Response to Comments from 802.16

Thank you for your review of our PAR and your comments. Our reply follows:

MBWA targets capabilities for “systems beyond IMT-2000,” which is shown in the Figure 4-2 from WP8F's Vision recommendation (see below).

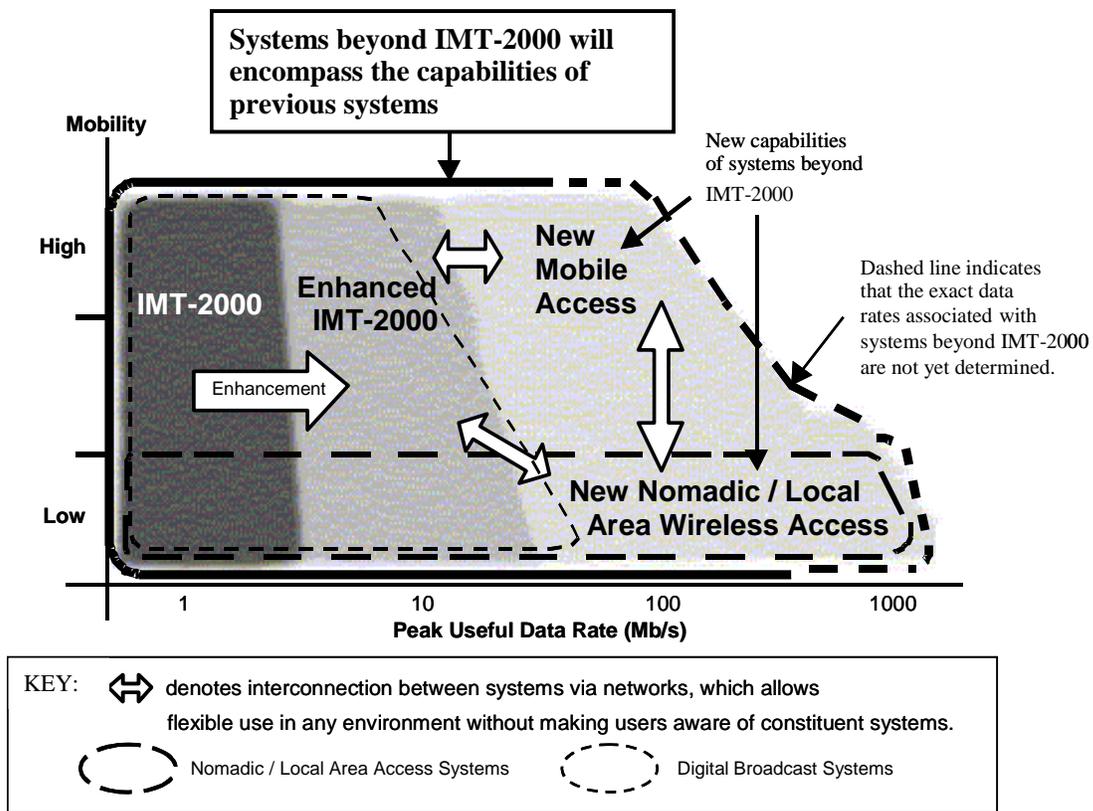
(1) We are concerned that the MBWA PAR has distinctly limited broad market potential because it is promoting a solution to directly compete with systems already developed or under development by worldwide partnerships of large, broadly supported Standards development Organizations operating in coordination with the ITU. We understand that there is some argument that the MBWA PAR could lead to a more efficient data solution, but the market potential is limited nevertheless.

In our view, the target for the MBWA project is described by the ITU-R Working Party 8F as “systems beyond IMT-2000,” which is not being addressed in any project within

Dark shading indicates existing capabilities, medium shading indicates enhancements to IMT-2000, and the lighter shading indicates new capabilities of systems beyond IMT-2000.

The degree of mobility as used in this figure is described as follows: Low mobility covers pedestrian speed, and high mobility covers high speed on highways or fast trains (60 km/h to ~250 km/h, or more).
